**APPLICATION FOR PERMISSION  
UNDER SECTION 16 OF  
THE TOWN PLANNING ORDINANCE  
(CAP. 131)**

For Official Use Only 請勿填寫此欄	Application No. 申請編號	A17C-PH/1100
	Date Received 收到日期	2025-12-29

擬議臨時公眾停車場(貨櫃車除外)和相關填土工程(為期3年)

**Responses to Comments from Government Departments on Planning Application No. A/YL-PH/996 (refer to Planning Department letter of 2 January, 2025)**

FIGURE 2

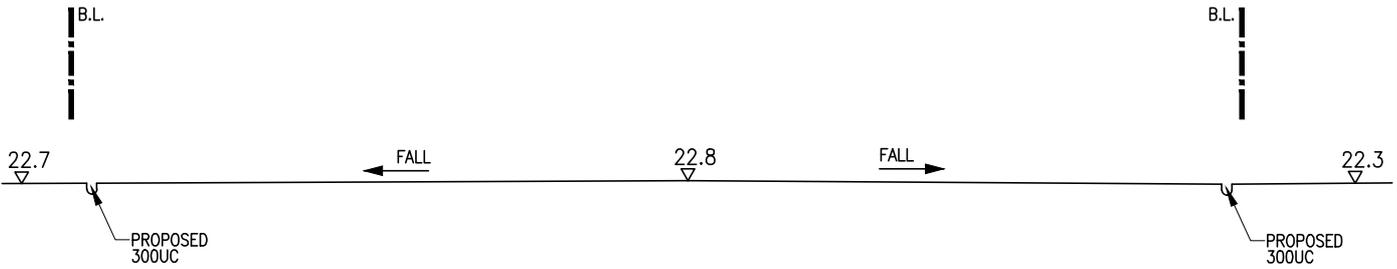
(4) The applicant is required to consider to replace the proposed 150 u-channel from point A to CP1 by a 225 u-channel.	Amended accordingly.
(5) The C.L. of channels/catchpits should be indicated in Figure 2.	Added accordingly.

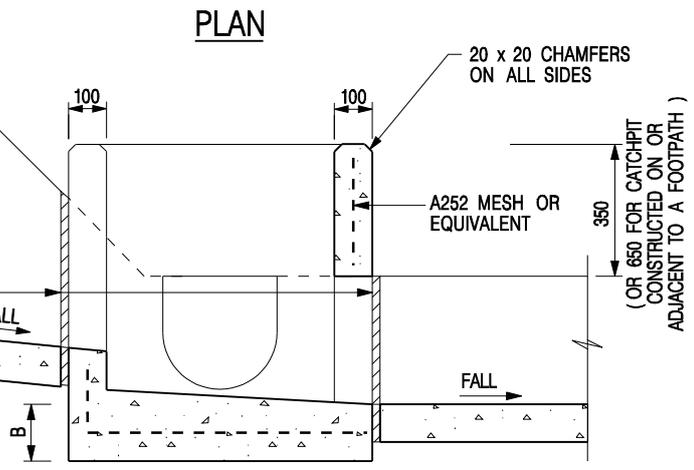
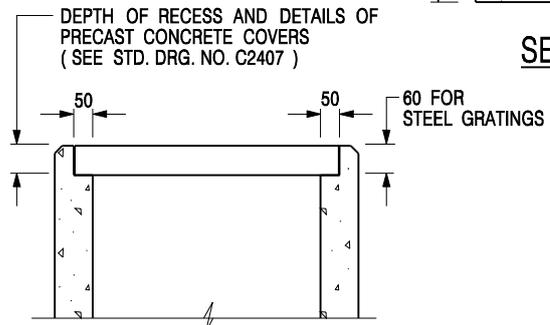
(6) The C.L., I.L. and B.L. at discharge point should be shown in Figure 4.	Added accordingly.
